MILITARY SPECIFICATION

CIRCUIT CARD ASSEMBLY - POWER SUPPLY, HUNDREDS DECADE
MATRIX AND READOUT - A3: 10547230

This amendment forms a part of Military Specification MIL-C-60578(MU) dated 18 June 1970.

FIGURE 2 TIMING CHART

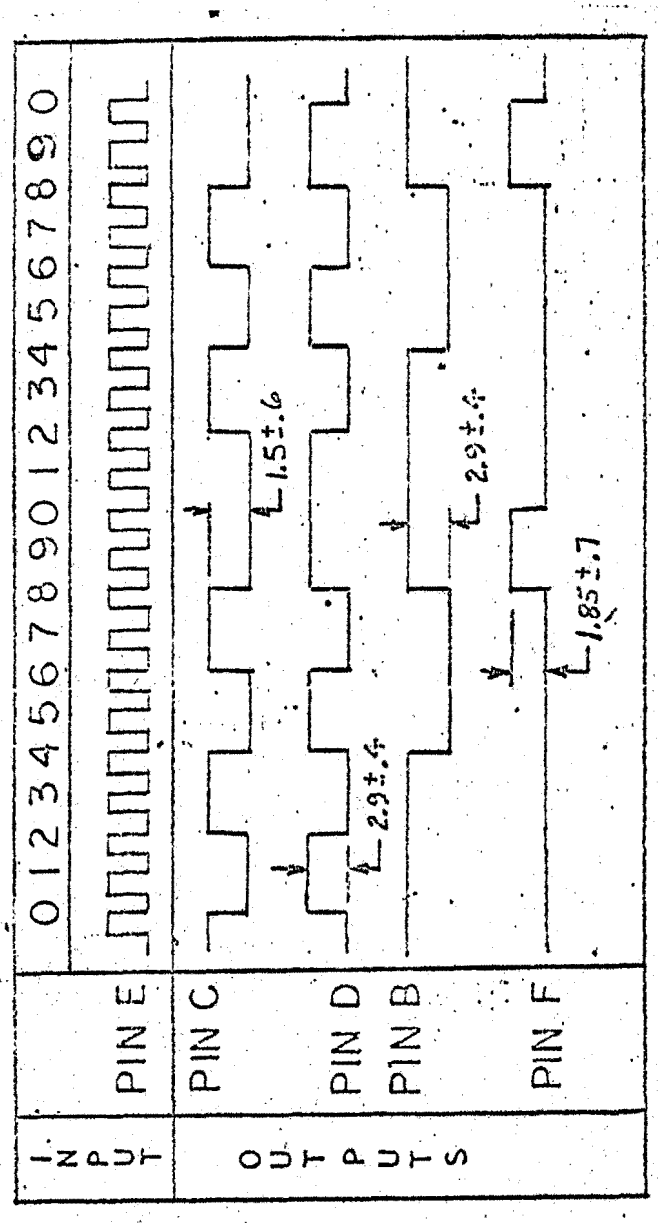
Figure 2: Delete and substitute:
